ASSESSMENT REPORT

Shoalhaven Starches Expansion Project Modification – Fermenter and Distillery Additions (MP 06_0228 MOD 2)

Figure 5 – Overview of the proposed additional fermenters

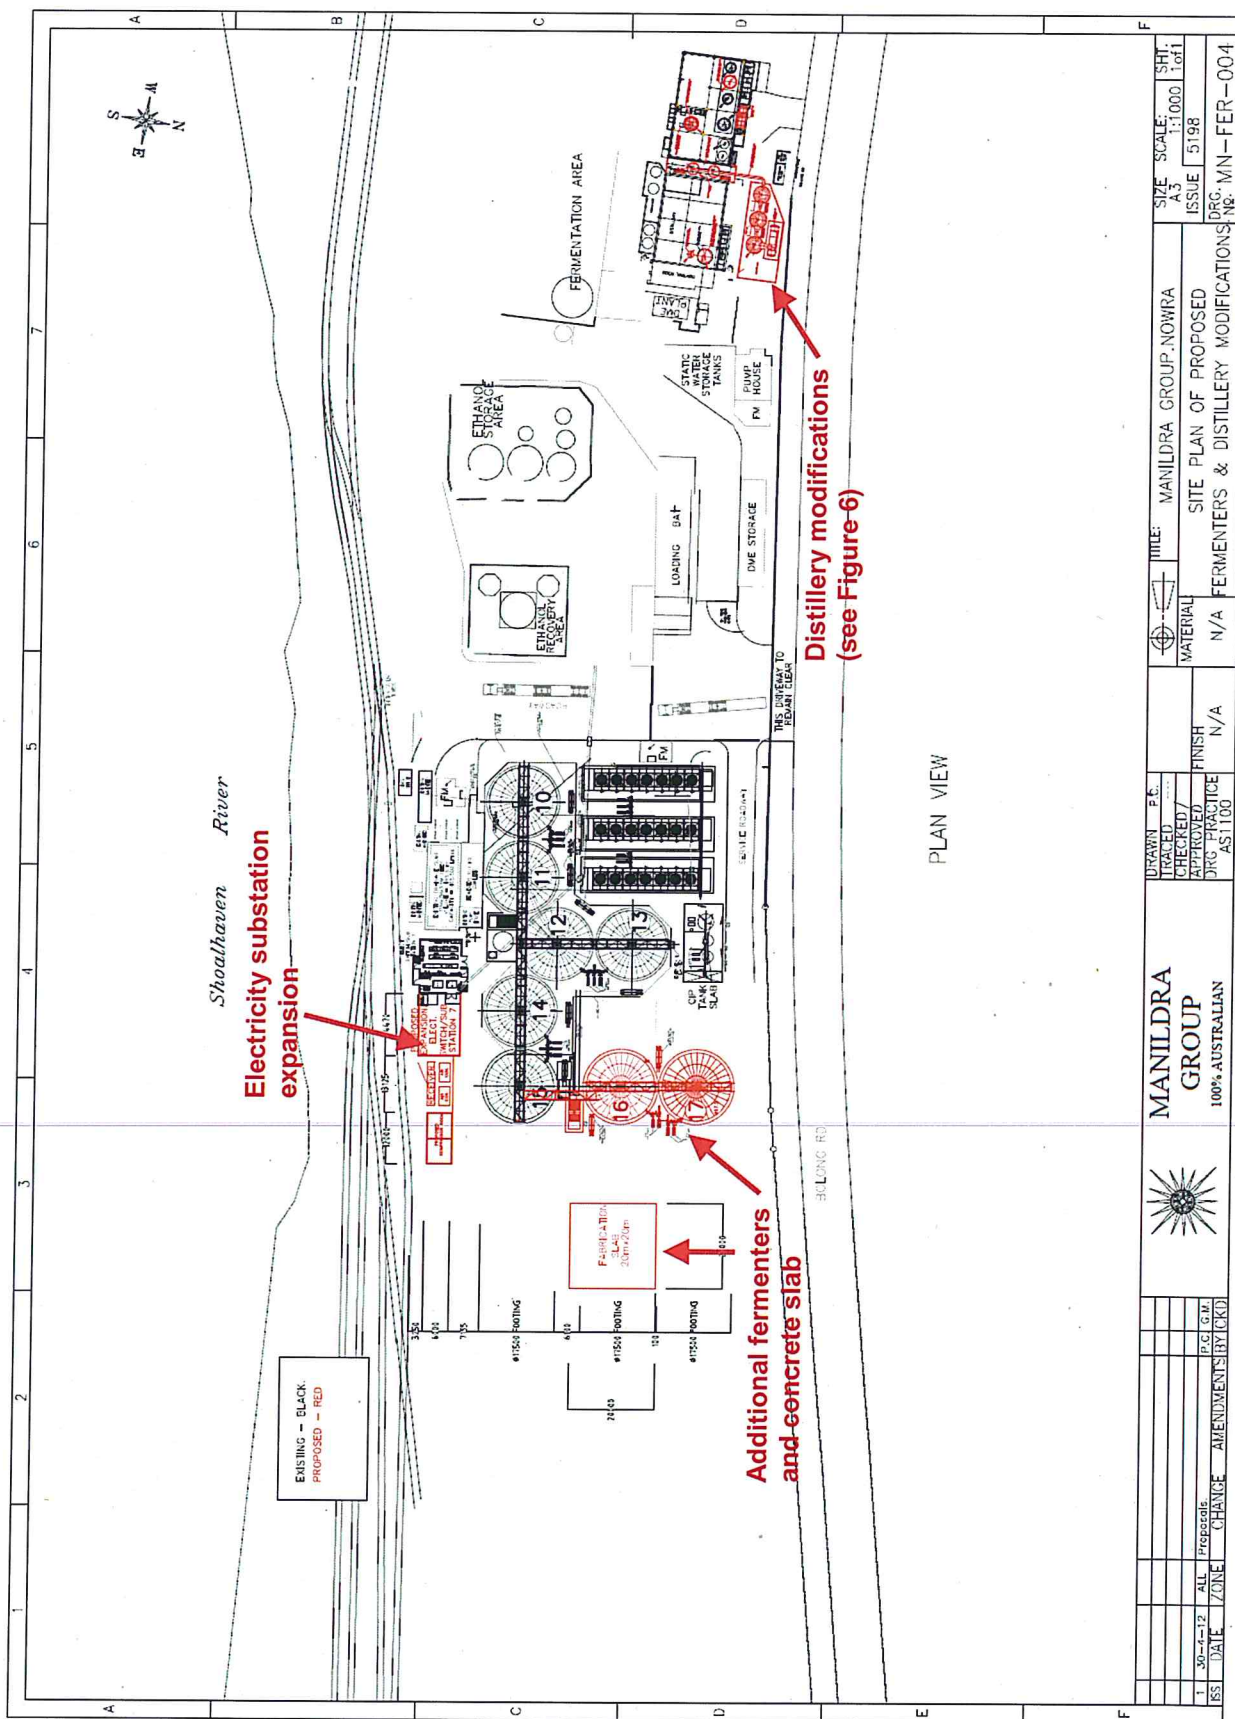
Of the proposed modifications to the site, the new fermenters (see Figure 5) and evaporator unit (see Figure 6) are likely to have the greatest impact on visual amenity.

The new fermenters would be identical to the existing tanks (ie. large metal cylindrical tanks 16m in diameter by 21m in height, with supporting gantries increasing to an overall height of 28m) and located on the northern side of the Starches site.

The VIA suggested that the new fermenters would be unlikely to be visible from the nearest residences given the location of existing mature vegetation located between the Starches site and these properties. In addition, as the new fermenters would be located on the northern boundary of the Starches site, the VIA concluded that they would not be visible from the village of Terara, which is located on the southern side of Shoalhaven River. As such, the Department considers that the vistas from the nearest residences are unlikely to be significantly altered. Further, as the new fermenters are identical to the existing tanks, they would be generally consistent with the bulk, scale and industrial character of the site and its surrounds.

Figure 6 – Overview of the proposed Distillery modifications

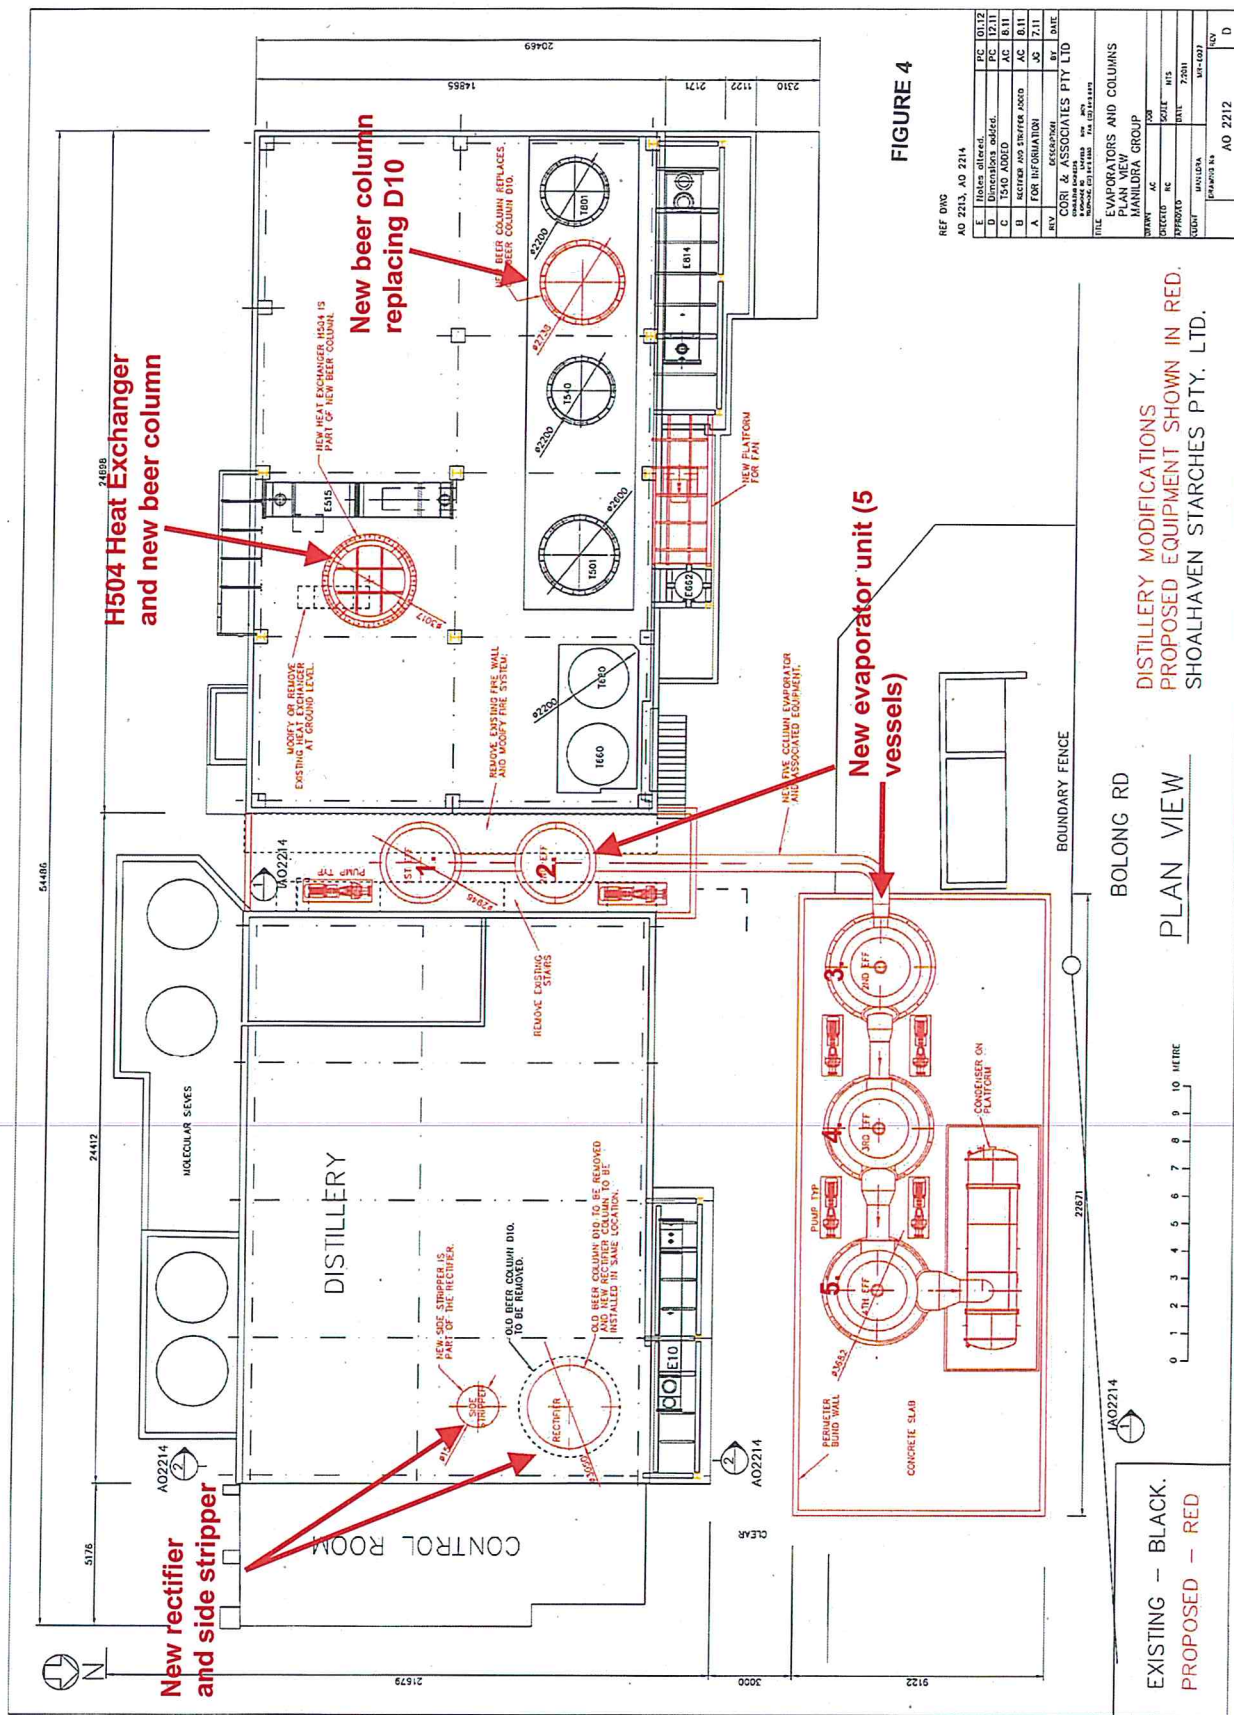
The new evaporator unit would consist of a series of 5 column like structures with a height ranging from 18.3m to 28.05m situated within and adjacent to the existing Distillery (see Figure 6).

Whilst the new beer column and two of the evaporator columns will be sited within and between the framework of the existing Distillery, the other three evaporator columns and associated equipment will be situated upon a platform that would be located between the Distillery and Bolong Road (see Figure 6). These three columns are likely to have the greatest potential visual impact.

Despite this, it is considered that the evaporator columns are likely to be largely indistinguishable from the existing plant, would be similar in height to components of the existing distillery (ie. around 28m), and would be sited within proximity of surrounding industrial sites.
